H TECHNICAL BULLETIN

HT250U-7.5-517 TRAILER AIR SUSPENSION TOP PLATE IMPROVEMENT

No: TRAILER AUS-005
Subject: *Product Update*
Date: July 1996 Revision: A

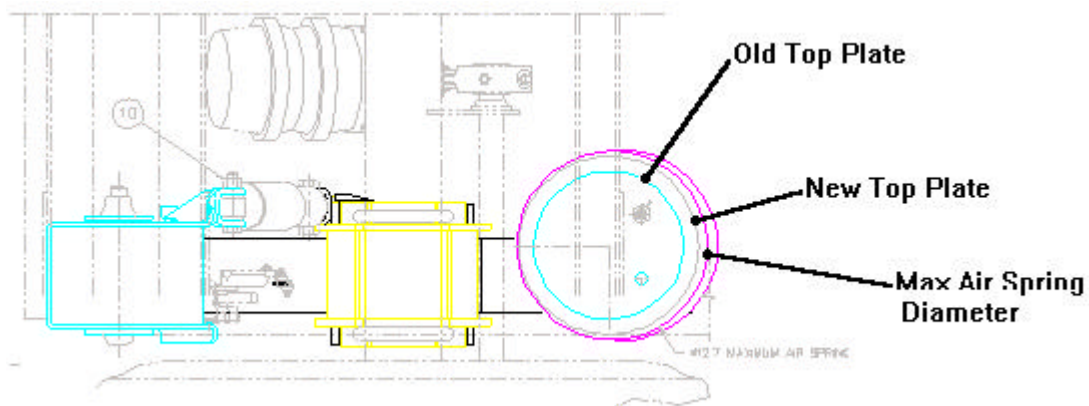
As part of our continuous product improvement program, Hendrickson has increased the diameter of the upper air spring plate on our HT250U-7.5-517 trailer air suspension. This improvement is intended to improve air spring durability by providing a larger surface for the compressed air spring to contact.

The upper air spring plate has increased from 10" (244mm) to 12" (300mm). Hendrickson specifies in installation drawings that the trailer design must allow a clearance of 12.7" in diameter for the expansion of the air spring. Consequently clearance changes should not be necessary for the improved top plate.

This detail is included in the current installation drawing for the suspension. Production staff however should be made aware of the change to allow for any tooling adjustments which may be required.
